Access Compliance Report Public Rights-of-Way (Curb Ramps)

Main Street: BOSTONIAN_DR Cross Street: CORTESE_DR Location: NE

ADA ID: RPRK211215134924 Ramp Type: Type 4 - Parallel Initial Pass/Fail: Pass Overall Compliance: No Severity Score: 20

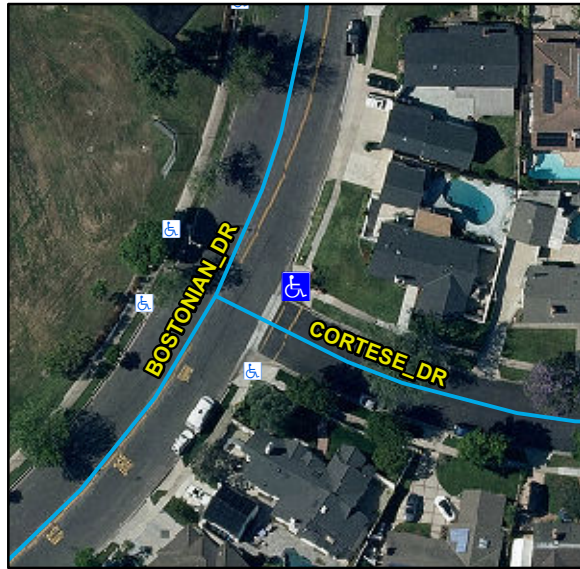
Remove & Replace Curb Ramp With Two New Directional Ramps or Equivalent. Restripe Crosswalk. Gutter Ponding Observed.
